Transport Access Program

Killara Station Upgrade

Determination Report

Figure 3-1 Photomontage showing the proposed changes to the existing view from Viewpoint 4

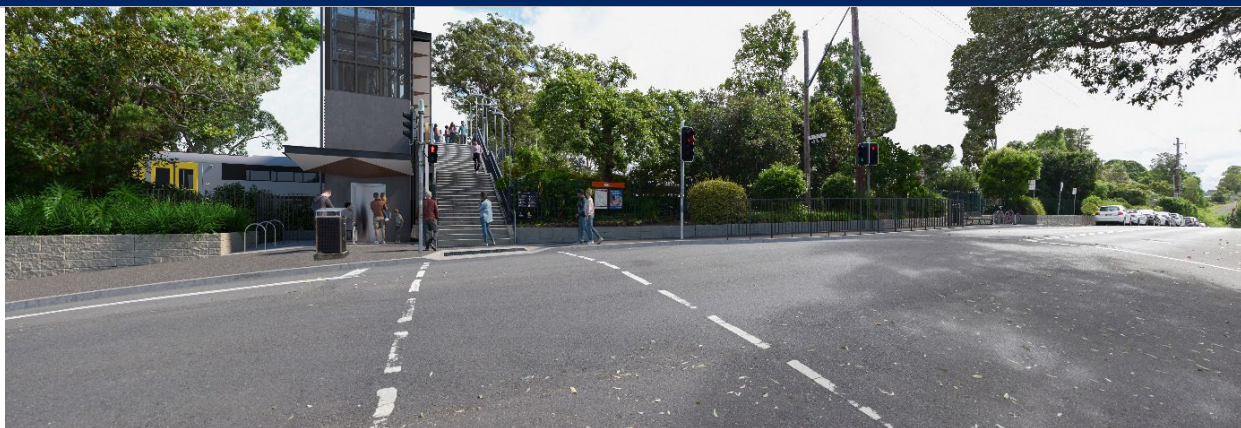
Design change	Discussion of impacts
<p>Reconfiguration of the Werona Avenue footpath, including:</p> <ul style="list-style-type: none"> removal of the existing footpath between the rail corridor and established garden bed modification and extension of the existing kerb line to provide a new footpath between the garden bed and Werona Avenue modification to road line markings formalisation of the garden bed structure minor relocation of the existing traffic lights within the garden bed removal of one parking space on the eastern side of Werona Avenue as a result of the realigned kerb and road line markings. 	<p>Potential impacts of the reconfiguration of the Werona Avenue footpath would generally be consistent with those assessed in the REF.</p> <p>Reconfiguration of the footpath would require the removal of one parking space on the eastern side of Werona Avenue as a result of the realigned kerb and line markings. The loss of an additional parking space as part of the Proposed Activity, in addition to the four assessed in the REF is not considered to be a substantial change. New line marking would direct traffic through the Werona Avenue intersection safely.</p> <p>Removal of the existing asphalt footpath and reinstatement with mulch would alleviate existing impacts to tree roots in the rail corridor and garden bed. However, Tree number 12 (<i>Cedrus deodara</i>) would need to be removed. Tree 12 has a poor form and shape with significant deadwood and dieback due to significant line clearance pruning. Tree 12 is unlikely to provide fauna habitat, constitute a significant element of the natural landscape and therefore its removal is not expected to be a significant impact. Tree 12 would be offset as per the requirements of <i>Transport for NSW Vegetation Offset Guide</i> (2019).</p> <p>The overall visual impact ratings from views towards the reconfigured footpath would be consistent with the findings of the REF. Descriptions for landscape character zone 4 and viewpoint 4 and 5, as well as the photomontage showing the proposed changes to the existing view from Viewpoint 4 have been updated to include the proposed change. The updated photomontage is shown in Figure 3-1.</p> <p>Three additional mitigation measures have been recommended to minimise visual impacts related to vegetation and planting along Werona Avenue (refer to CoA 38 in Appendix B). The first measure recommends that landscaping efforts between the existing garden bed and the station garden to be of complimentary nature to the existing heritage garden within the station. The second measure recommends that planting of shrubs and groundcovers within the garden bed between the fenced station and the proposed footpath on Werona Avenue be graded from short to taller shrubs towards the fence to reduce prominence of the station fencing. The third measure recommends that replacement of Tree number 12 should consider appropriate species selection with regard to the heritage character of the station and the surrounding landscape.</p>

Figure 3-2 Revised key features of the Proposed Activity (indicative only, subject to detailed design)

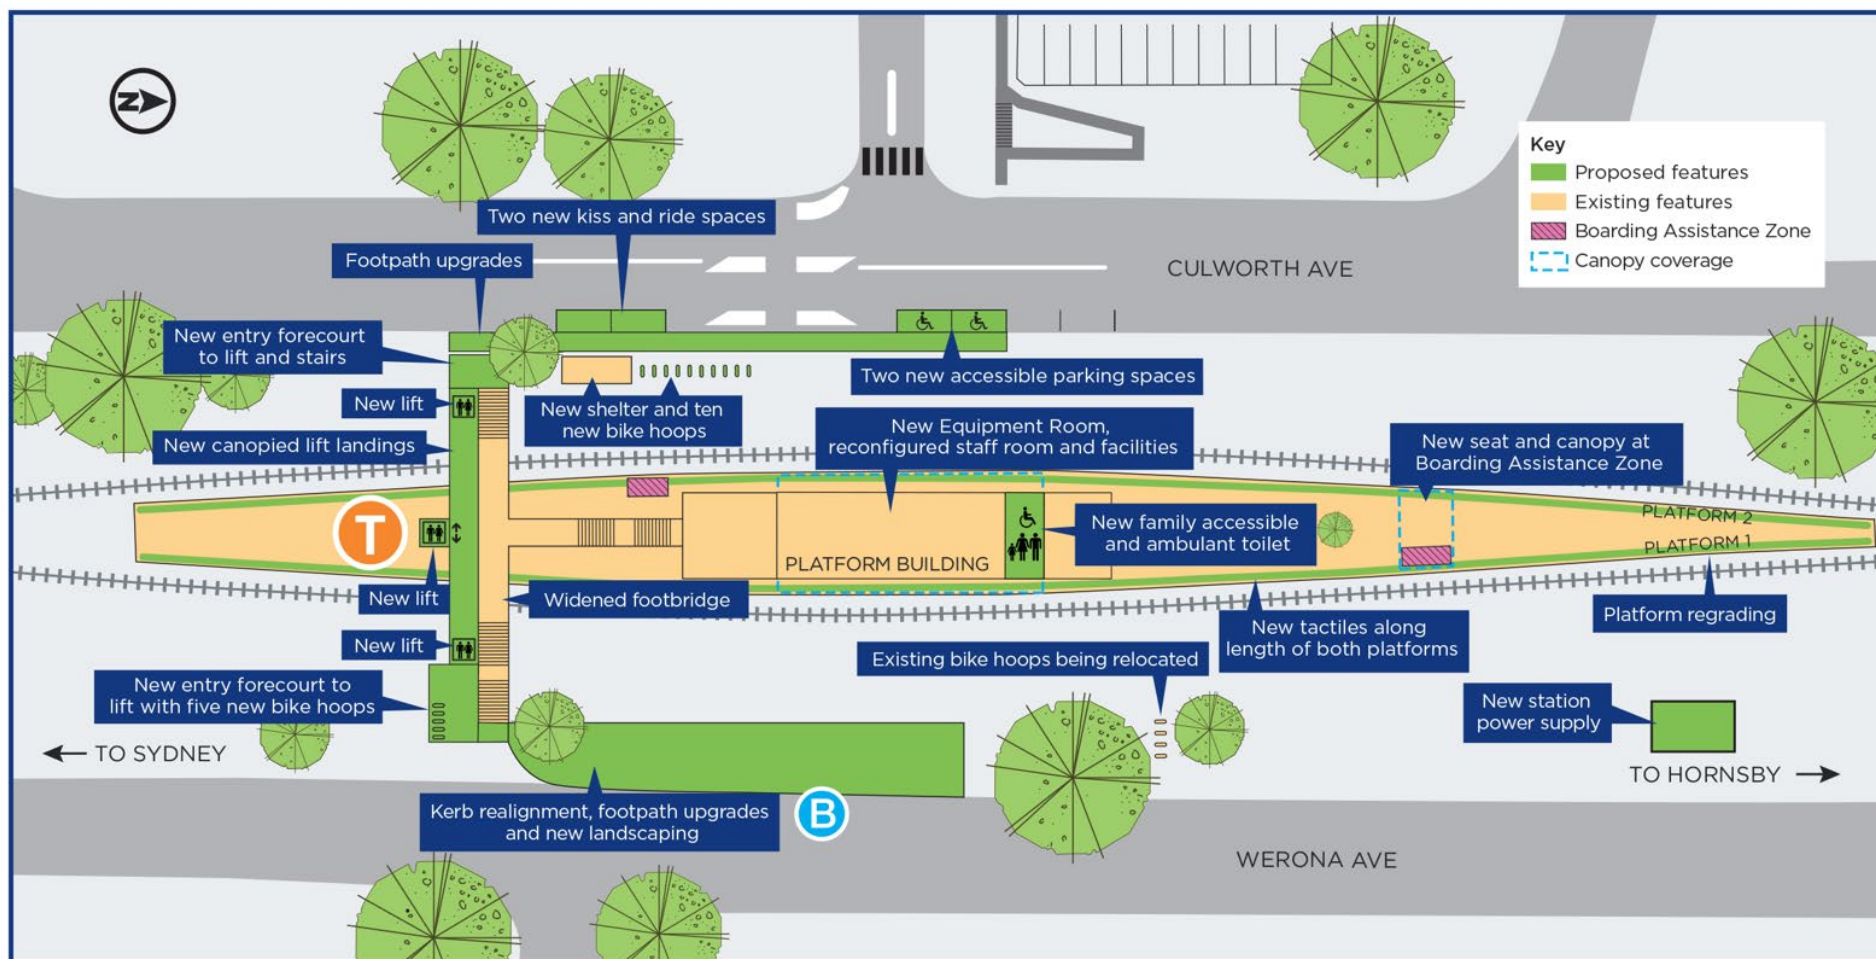
Further design development has resulted in changes to the design of the Proposed Activity since the Killara Station Upgrade REF was prepared and placed on public display. The revised key features of the Proposed Activity are shown in Figure 3-2. The revised work areas and compound location required for the Proposed Activity are shown in Figure 3-3.

Figure 2-1 Proposed electrical upgrades

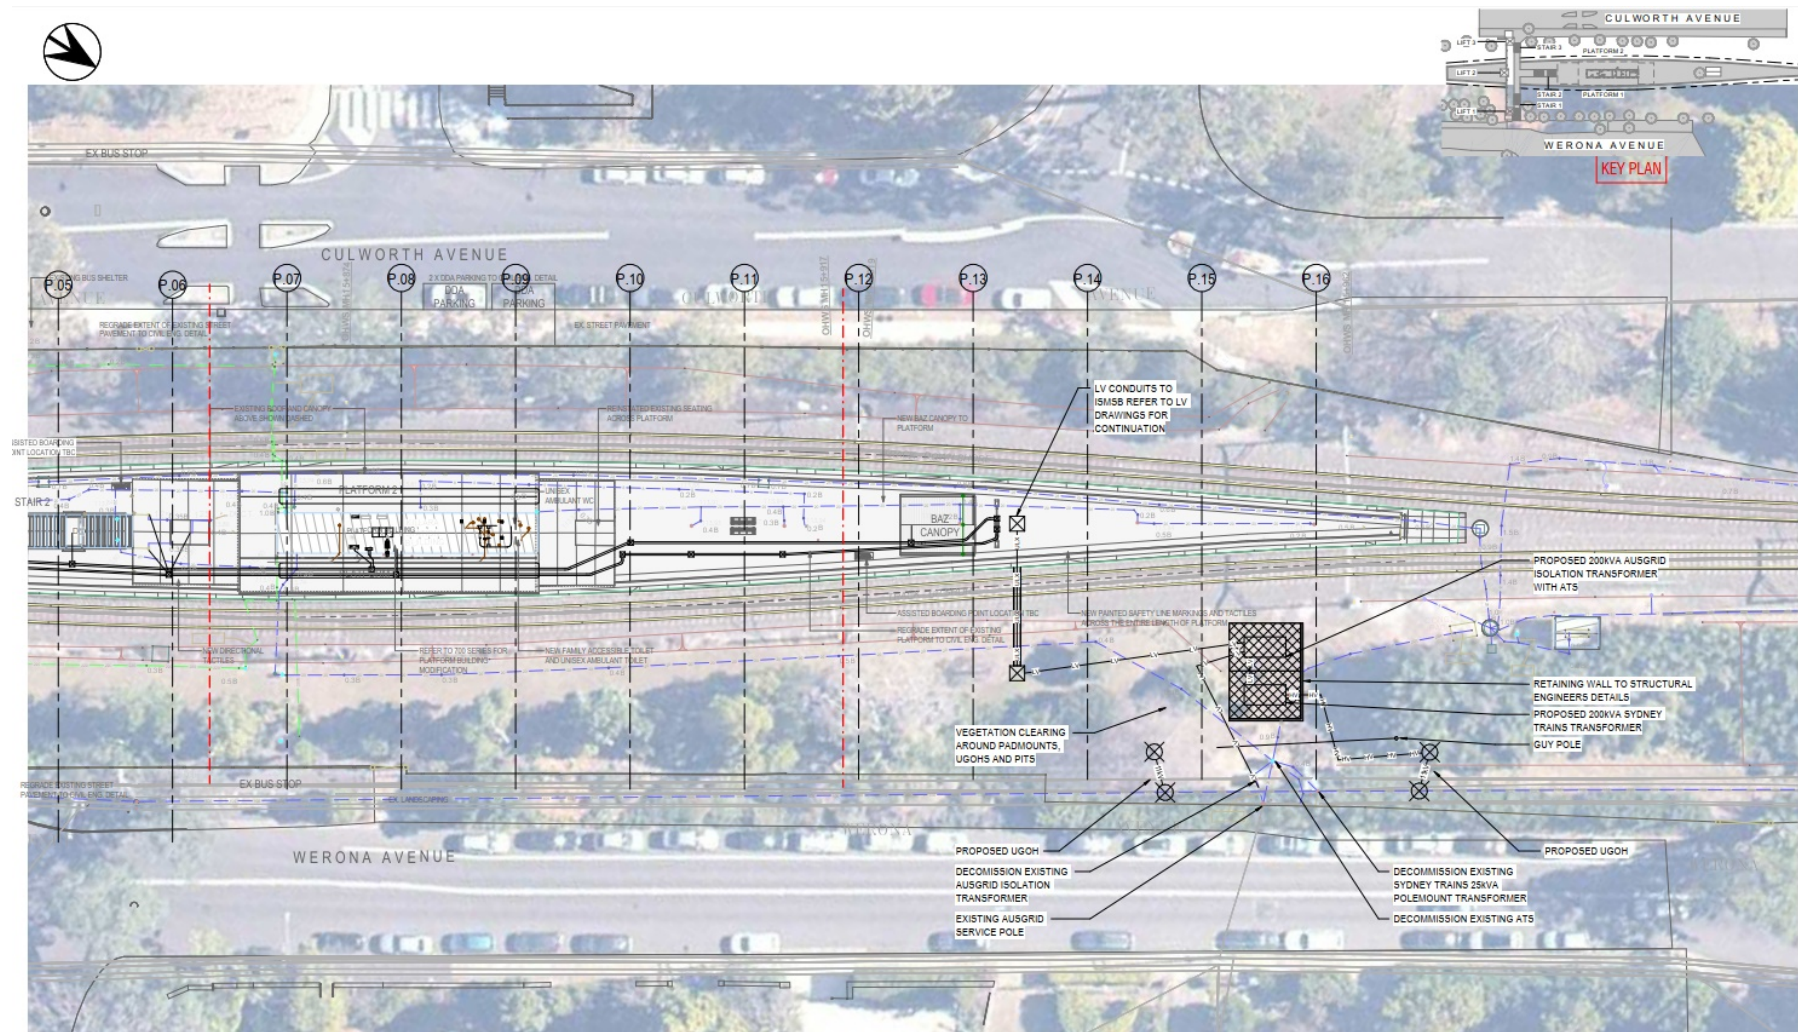
Four new power poles and an additional transformer would be placed at the north eastern end of Killara Station, to the north of the heritage garden area. The power poles and transformer would be placed away from the location of the formal gardens. The separation distance of the new power poles to the station and gardens is shown in Figure 2-1). The new poles would replace two existing poles in the same area and are not likely to change existing views to the station. The new transformer would be placed away from the formal garden area, however minor vegetation removal would be required (outside the formal garden area). The additional transformer would be a new visible feature at the station.

Figure 2-3 Proposed station building layout

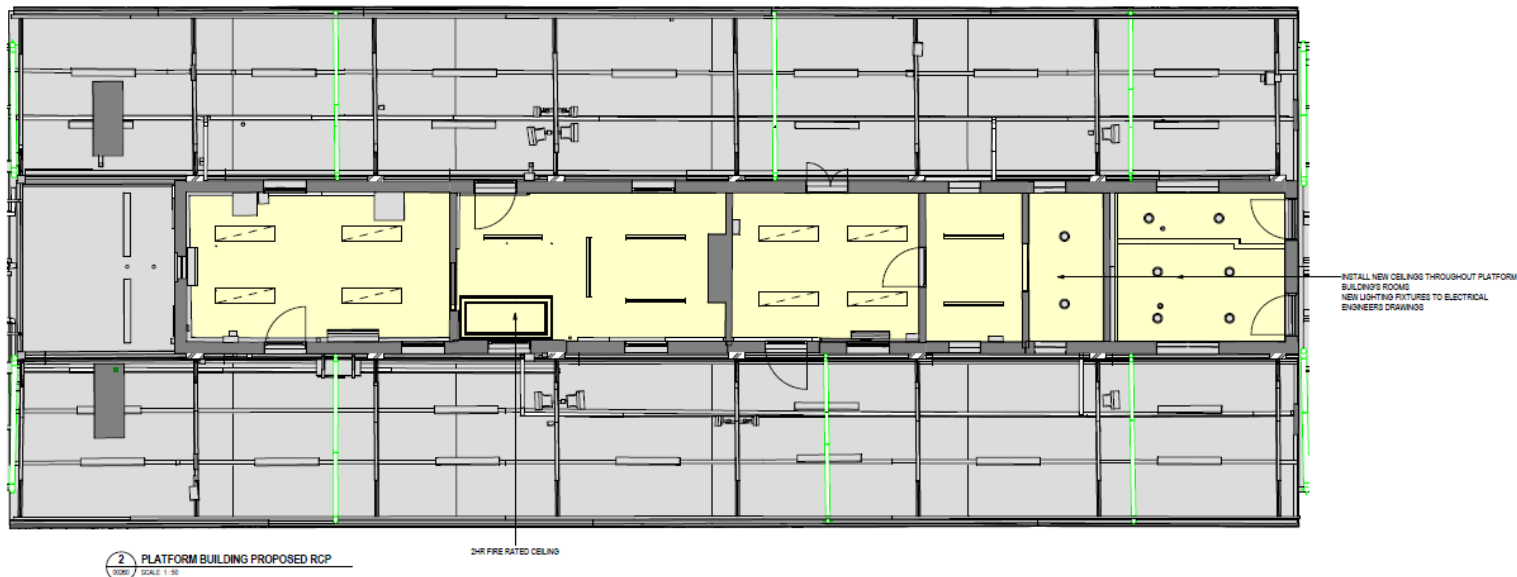
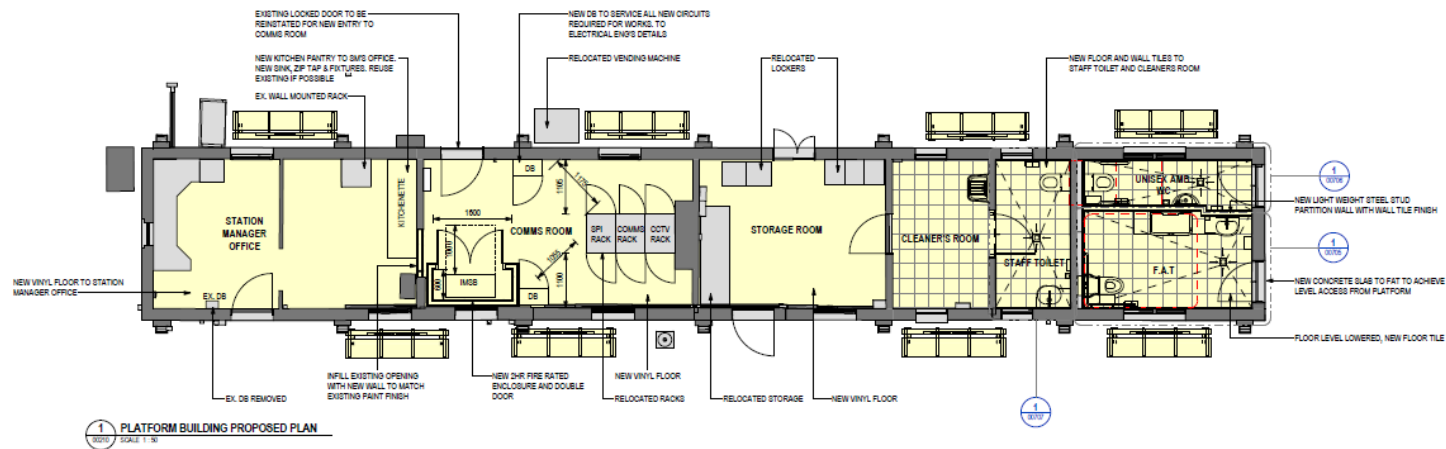
The proposed design would remove the modern partition wall and reinstall a door to the former Communications Room, and this would become a Cleaners Room. A second door would be installed into a new Staff Toilet, which is currently a storage area (Plate 9). The removal of the modern wall would not have an impact to the heritage fabric inside the station building. The new Staff Toilet would require the existing floor to be raised up to make a level entry way. A door would be added to the existing fenestration and the floor in the current storage room would be raised to be level with the surrounding rooms (Figure 2-3).

There are no records as to why there is a step down into the current storage area, however, raising the floor is likely to have a minor impact to the significance of the station building. It is presumed that services to the new Staff Toilet would be through the floor of the station building. If so, this impact is considered to be minor as the original layout of the station building would be retained, and new services laid discretely through the floor of the station. All existing external door and transom windows would remain and would not be impacted (Figure 2-3).

Figure 1 – Key features of the amended Proposed Activity

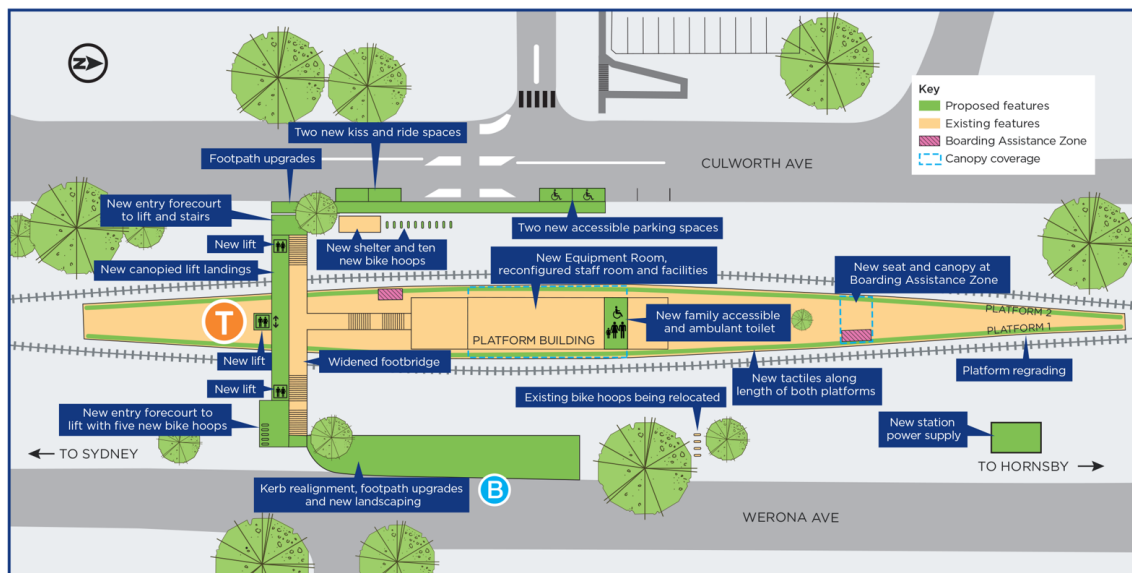
- the proposed boarding assistance zone (BAZ) canopy at the southern end of the station as coverage from the existing platform canopy is in close proximity
- the proposed pedestrian crossing at Culworth Avenue
- the proposed ramp to the existing bus stop on Werona Avenue.
